Title: MANDATORY BEARING INSPECTION/RECALL

Revision: **1**

Service Instruction No. 04-9 Revision 1

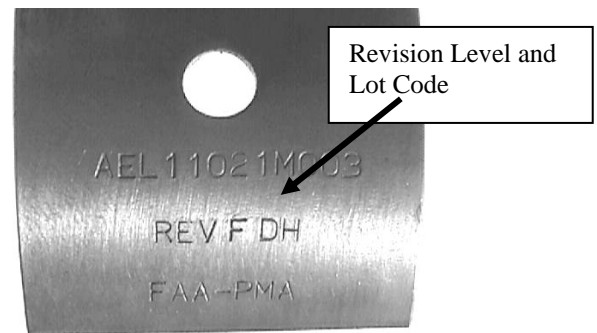
- Determine if any AEL13884 STD Rev. G, AEL11021 STD or M003 Rev. F or AEL13521 STD Rev. D replacement bearings for Lycoming engines have been purchased from ECi since June 1, 2004. The bearings may be further identified by the lot code stamped on the back of the bearing halves as shown in the photograph at the right and on the next page. The Rev. level and Lot Code are also stamped on the label affixed to the box in which the bearings are packaged.
